**ENVIRONMENTAL ASSESSMENT  
PROPOSED MOTHER LODE PROJECT**

**FINAL  
ENVIRONMENTAL ASSESSMENT  
PROPOSED MOTHER LODE PROJECT**

**APPENDIX B  
COMMENTS ON DRAFT EA**

APPENDIX A - FIGURE 1  
HYDROGEOLOGIC MAP OF THE  
CRATER FLAT AREA AND VICINITY  
Source: Hydro-Search, Inc. 1989

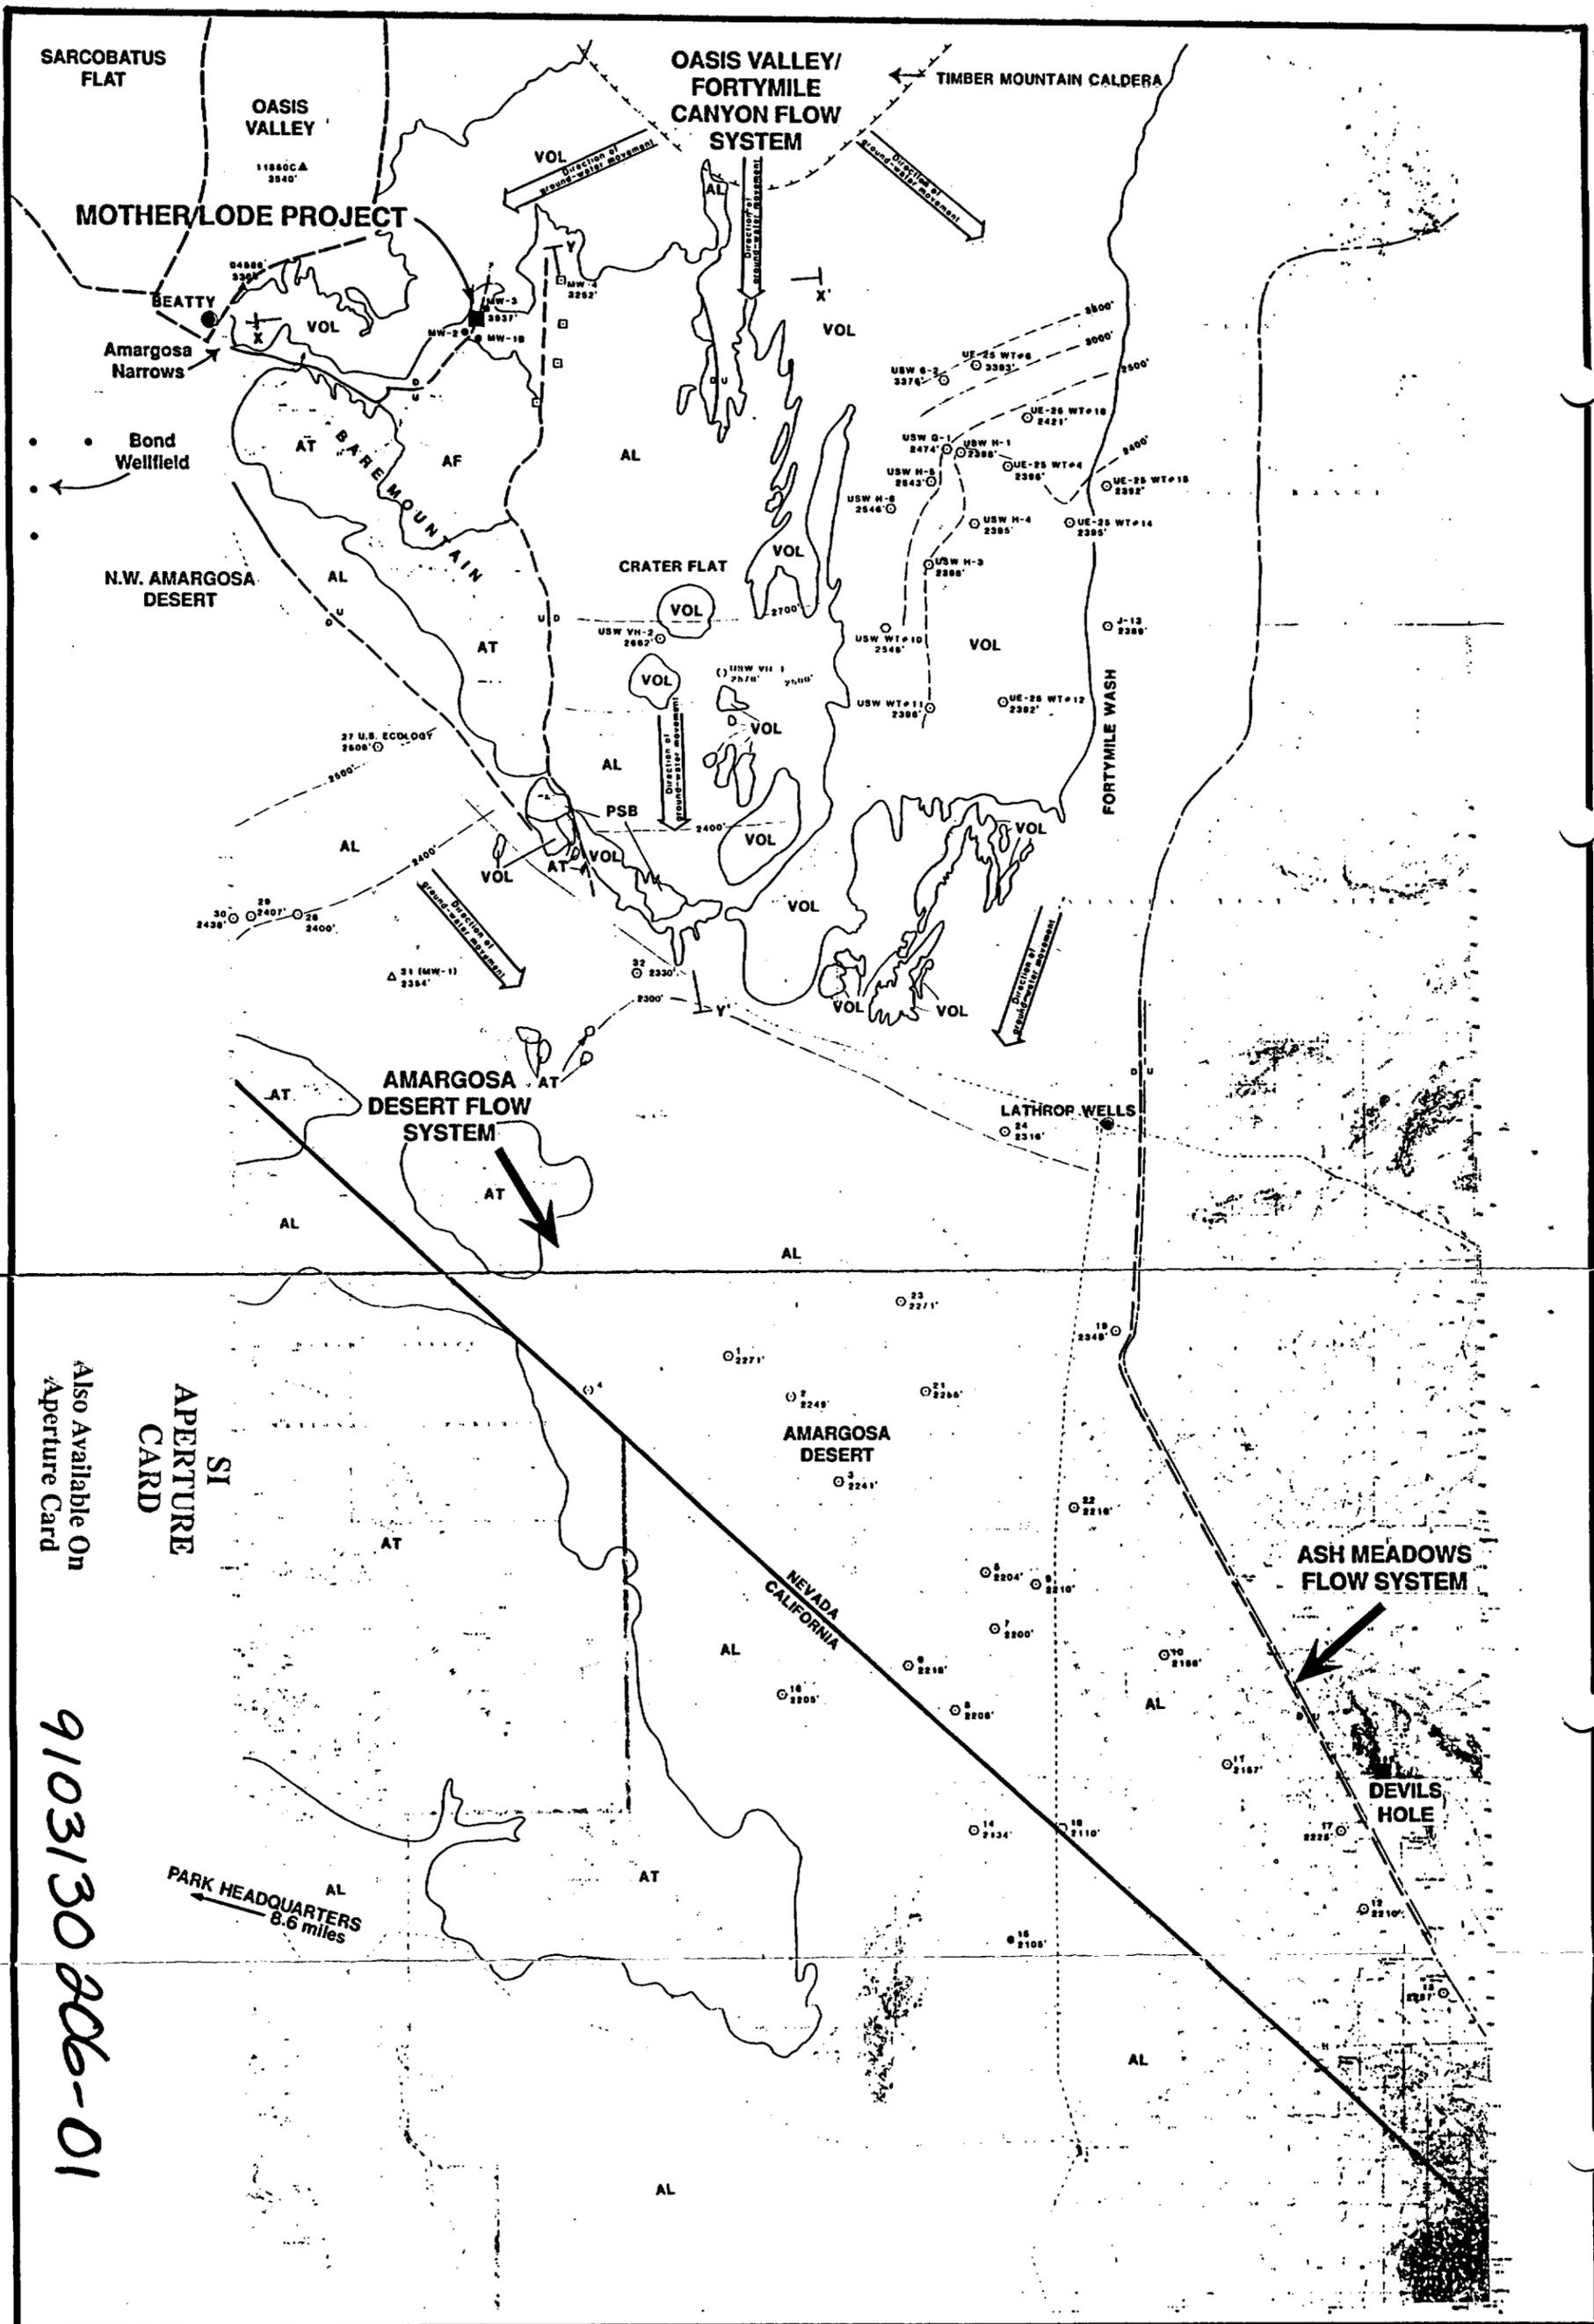
Change to read: The Oasis Valley/Fortymile Canyon groundwater system is indirectly connected to the Amargosa Desert flow system through Oasis Valley and ultimately the Amargosa Narrows near Beatty (see Appendix A, Figure 1) and farther south and west ... Malmberg and Eakin 1962).
